**Invensys Response to  
Request for Additional Information (RAI)**  
Ref: Letter dated December 8, 2010, NRC to Invensys

<u>Attachment</u>	<u>RAI No.</u>	<u>Description</u>
1	1	RXM Safety/Non-safety Interface versus Interim Staff Guidance (ISG)-4
2	2	Assignment of Safety-related and Non-safety I/O to RXM Chassis
3	3	Testing Related to RXM Chassis Failures
4	4	Document Listing for FPGA Development
5	5	Response Time Compliance with EPRI 107330
6	6	Determinism and Use of Interrupts

## Main Processor

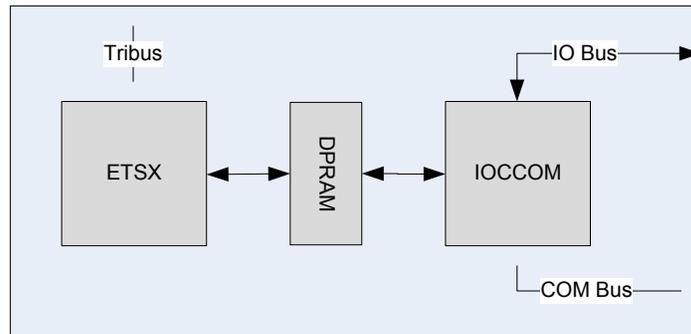
In Section 2.1.3.3 of the Triconex Topical Report Revision 3, Invensys document 7286-545-1, Invensys states that the TriStation 1131 function subset does not allow constructs that could lead to non-deterministic timing. However, there is no mention of the deterministic behavior of the Tricon design itself. Please provide a description of the deterministic behavior of the Tricon platform, including interrupt handling.

The 3008N Main Processor module consists of three main subsystems as shown in the figure below:

Each subsystem consists of a microprocessor and memory subsystem. The ETSX (Enhanced Triconex System Executive) is responsible for running the user defined application program on the Application Processor. The IOCCOM Processor is responsible for communications with the I/O modules in the system and the Tricon communications modules (TCM). The DPRAM provides the interface between the ETSX and IOCCOM. The DPRAM is divided into several sections:
